30 September 2016  
Our Ref: 26522 KAB  
Your Ref: DA485-12-2002

**REQUEST TO MODIFY A DEVELOPMENT APPROVAL UNDER SECTION 75W OF THE EP&A ACT –  
DEVELOPMENT APPLICATION 485-12-2002 FOR A RESIDENTIAL SUBDIVISION – NADINE STREET,  
SANCTUARY POINT.**

Allen Price and Scarratts seeks to lodge a S75W modification application to this application primarily to increase the number of proposed residential allotments from thirty-nine (39) residential allotments and open space for stormwater drainage control as well as residential use, to fifty-one (51) residential allotments and a drainage reserve.

Figure 1 – Approved Lot Layout under development consent 486-12-2002 – Allen Price & Associates 2002

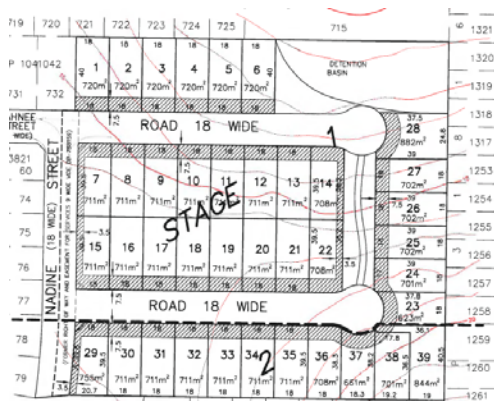
- **Reconfiguration of the proposed lot layout and increasing the number of lots from 39 to 51** – The site lot layout is proposed to be altered primarily as a result of the deletion of the detention basin and the alteration of the lot widths.

The proposed changes to the allotment sizes will create slightly narrower allotments that are more suitable to modern project dwelling design, which also satisfies market demand and makes more efficient use of the land.

The size and width of the lots were previously approved under development consent 486-12-2002 is detailed in the following insert:

It is a DCP requirement that the minimum width of non-corner lots is 16m with the minimum depth being 30m. Some of the proposed lots are not consistent with the minimum lot width controls of the DCP however, are in accordance with the performance criteria. The modification provides a more varied range and mix of lot sizes to ensure dwelling variety that meets user requirements and lots that area suitably solar orientated.

Notwithstanding the fact that that there is a modest reduction in the minimum lot width from 17m to 16m, this is compensated by the fact that the lot areas exceed the minimum lot size requirement by at least 5%.
